PR #: Three (3)

TO: David Beiersdorfer Jr.
Endeavor Construction
977 State Route 28
Millford, Ohio 45150RE: Gallatin Co. Alternative School & Field House
Gallatin County, Kentucky
BG 12-133
RTA 0914

DESCRIPTION: Soil Condition Proposals at the Plan-South Alternative School & Field House Building Pad Area (a follow up to the response to RFI#004).

Subject Subgrade

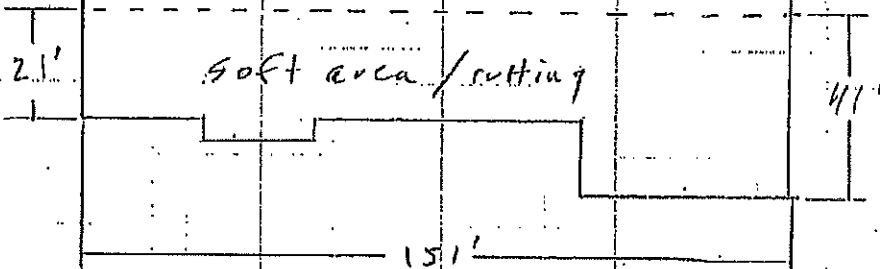
S&ME observed the building pad subgrade. Based on discussion with Mr. Jones, it is understood the north section of the building pad was previously a parking area and stability in the area is not a concern. The south area of the building pad, as shown on the attached sketch, was previously proofrolled and ruts were observed to depths of 6 to 8 inches. Hand augering was performed at several locations. Weak clayey silt soils were encountered to a depth of approximately 12 inches. The soils observed would typically become unstable when exposed to excess moisture.

S&ME recommends the soft soils be cut to a depth of 12 inches below subgrade. The soils should be replaced with crushed stone base (Kentucky Department of Highways Standard Specification Item 805.15 or similar crushed stone material).

The portion of the building pad area on the south side that did not meet proof-roll should be undercut 12" and brought to subgrade elevation with crushed stone per the Geotechnical Engineer's observation and recommendation letter dated February 12, 2013.
